Committee: Development	Date: 10 May 2012	Classification: Unrestricted	Agenda Item No:
Report of: Corporate Director of Development and Renewal Case Officer: Kamlesh Harris		Title: Planning Application for Decision	
		Ref No : PA/11/02495	
		Ward(s): Spitalfields and Banglatown

Location: 4 Wilkes Street, London E1 1QF

Proposal: Erection of roof extension to provide additional office space.

Proposed Front Elevation:

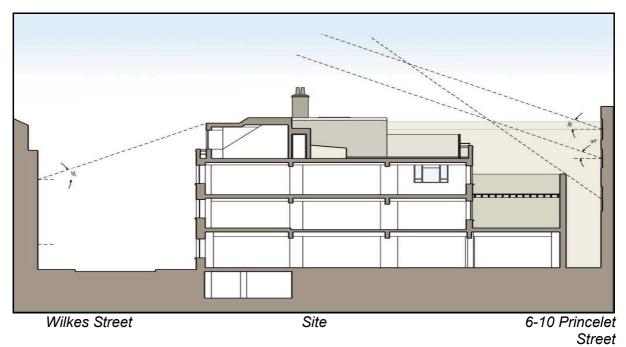
8.11 When viewed from Wilkes Street or in longer views down Puma Court it is apparent that the two properties on either side of number 4 Wilkes Street have an additional fourth storey in the form of mansard roofs. The creation of an additional mansard-type storey is therefore considered in keeping with the character and appearance of the terrace and surrounding

- area. Although the host building is of a more modern construction than its neighbours, a traditional mansard form is still seen as an acceptable form of addition as the mansard form is frequently used on buildings from many different eras.

- 8.12 The roof addition, the terrace and the terrace screening can also be seen from residential properties behind the application site (including those which front Fournier Street and Princelet Street). Officers consider that the visual impact of the terrace screening is limited as it has been set back from the edge of the roof, and the mansard itself is a common structure in the roofscape in this area.

- 8.13 The proposal has limited impact on the streetscene, and as such would have limited impact on the setting of the adjoining Listed Buildings. In overall terms the proposed additions are considered to relate well to the host building and are acceptable in terms of design. The proposal pays special regard to the desirability of preserving the setting of the adjoining Listed Buildings, and would preserve the character and appearance of the Fournier Street / Brick Lane Conservation Area.

West / East Section Through Proposal

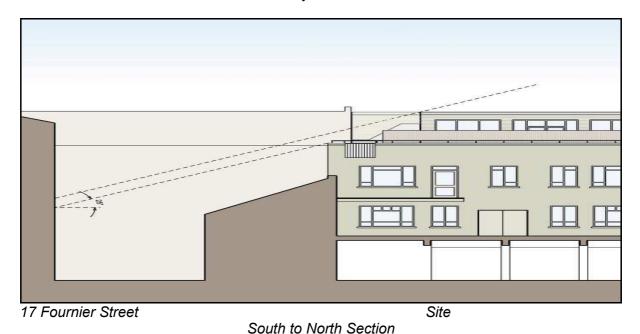
- 8.19 Appendix 2 of the Design, Access and Impact Statement submitted with the application includes a Daylight analysis.
- 8.20 The diagram below shows the impact of the proposal on 6 10 Princelet Street (located to the east of 4 Wilkes Street, or on the right-hand side the diagram below). The diagram also shows the impact on the property on the opposite side of Wilkes Street to the West.

8.21 The scheme would have very little impact on 6 – 10 Princelet Street in terms of loss of daylight. The scheme would result in a slight decrease in VSC (Vertical Sky Component) levels on the property to the West. However, the resultant VSC level would be 0.88 times its former value, which is within the limits set by the BRE.

8.22 The above diagram shows the north/south section, south being on the left of the diagram. Fournier Street lies south of the application site. The analysis shows that the daylight impact on 17 and 19 Fournier is acceptable and will meet BRE Guidelines. The set back from the shared boundary, and limited depth of the extension ensures that there is no significant impact on 2 Wilkes Street.
